Access Compliance Report Public Rights-of-Way (Pedestrian Signals)

Main Street: VALENCIA_AVE Cross Street: CARBON_CANYON_RD Location: NE

ADA ID: SGAT210920090119 Signal Type: One Push Button-APS Overall Compliance: No Severity Scores: BTN 1: 25 BTN 2: N/A No BTN: N/A

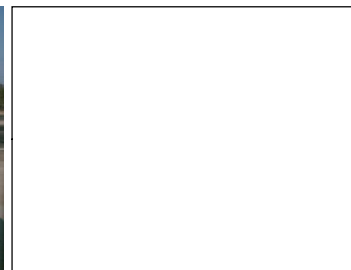
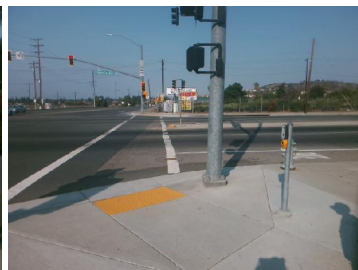
Yes B 1 Closed Fist Operation?	Yes	N/A	B 2 Closed Fist Operation?	N/A	
Yes B 1 Diameter (in)	2.25	N/A	B 2 Diameter (in)	N/A	
N/A B 1 Crossing Direction	W	N/A	B 2 Crossing Direction	N/A	
Yes B 1 DistanceTo XWalk (in)	46	N/A	B 2 DistanceTo XWalk (in)	N/A	
No B 1 DistanceTo Curb (in)	110	N/A	B 2 DistanceTo Curb (in)	N/A	
Parcel Identification Number	308-051-18				
Google Street View Link					
http://www.google.com/maps/@?api=1&map_action=pano&viewpoint=33.9243446,-117.84751537

Possible Solutions: Replace Signal Push Button With APS Button. Remove & Relocate Sign.
